August 4, 2021

RE: 118 Olive Street

I reviewed the drawings and evaluated the site context. My comments and recommendations are as follows:

Proposed Front Elevation

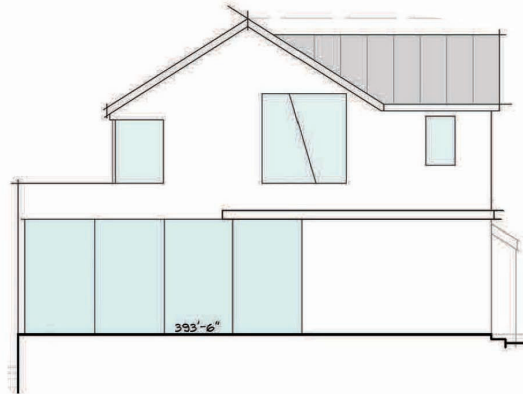
1. The use of stone on the front elevation, while not carrying it around consistently on the other three facades would not be consistent with Residential Design Guideline 3.2.2.

2. The column detail shown at the entry is not well detailed, and does not look like it is an integral part of the facade,
3. The existing house is simple in its forms, and the addition should relate to that. However, the garage form and the popout form on the right side elevation at the Family Room/Kitchen are quite foreign to main forms of the house and to each other. **We have created a deck over the garage per Canon suggestion**
3. There appears to be no trim at the window, and windows do not appear to be substantially recessed from the face of the wall which would not be consistent with Residential Design Guideline 3.7.4.

The exterior walls will be 6" thick and the windows will be recessed as far as practical. For this style of architecture, window trim would not be appropriate

The element in question is not a column. It is the end of a wall that extends from the entry to the face of the building. Comment is N/A

The stone wraps around the architectural element @ The front of the house and is distinct. No such elements exist @ sides & rear to create a similar condition. The proposed color of the stone compliments & blends with the color of the roof

Proposed Right Side Elevation

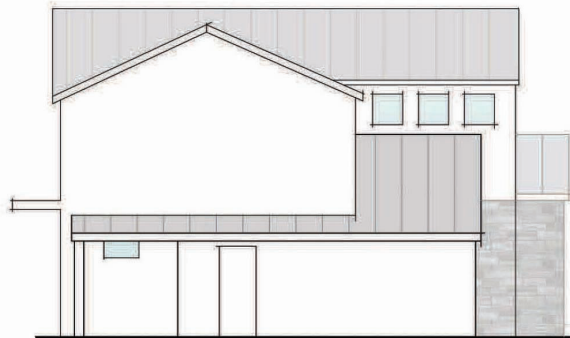
4. Gable roof slopes do not match which would not be consistent with Residential Design Guideline 3.5.1.

unequal slopes
@ a single gable

The roofs in question oppose each other and no contrast between their slope differences will be visually apparent. The roof slopes were chosen to blend the house appropriately and to keep the mass of the house appealing. If the side gable slope were to match the front of the house, mass would be increased. I believe the intent of the code is to prevent unequal slopes on the gable as illustrated in the drawing above, left. Larry Canon just approved a house w/dissimilar roof slopes @ 515 Bachman Ave

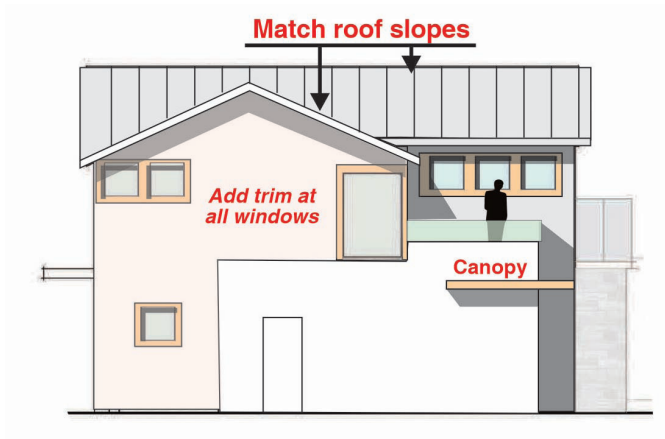
1. Use similar flat roof forms on both the garage and Family room/Kitchen popout. Optional usable roof deck over garage for Bedroom 2 and/or Master Bedroom.
2. Integrate the entry column into the garage wall, and add a conopy over the entry and the garage.

We have created a deck over the Garage per our attached revised plan. Our design steps the deck back to the garage face providing a stepped back more attractive street presence

As mentioned earlier on the previous page point number 2., there is no entry column

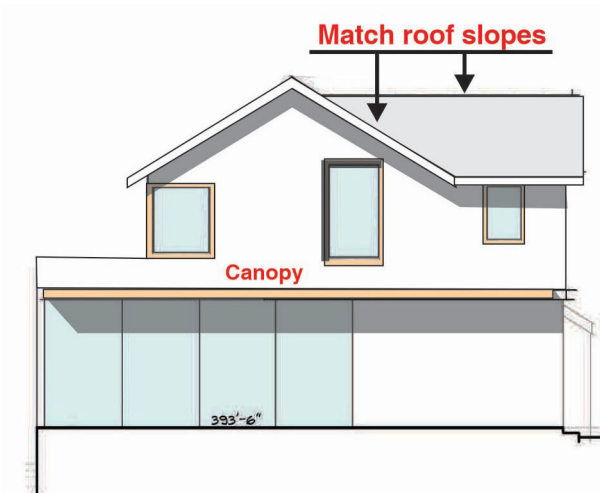
3. Recess the garage door - similar to new home nearby to the right (photo below). *The garage door has been recessed by 1'-0"*
4. Match the gable roof slopes.
5. Add trim to all windows consistent with Residential Design Guideline 3.7.4 and recess large windows- similar to new home nearby to the right (photo above). *This design calls for trimless, recessed windows per the exception noted @3.7.4, Page 4 of Canon's report*
6. Eliminate the stone on te front facade. *Answered on the previous page, point number 1.*

Answered on the previous page point number 4., The photo that Larry Canon is using of 114 Olive is my design. Those roof slopes do not match, but since the roof directions oppose each other, the appearance is wholly acceptable and not apparent resulting in reduced mass and bulk

As discussed earlier, the dissimilar roof slopes are acceptable as we have applied them

The canopy as extended per Larry Canon is not desirable. This is a north elevation and we prefer as much solar access as possible here. The canopy as designed, it is purely functional- It sheds the main person door and the future kitchen area from the weather.
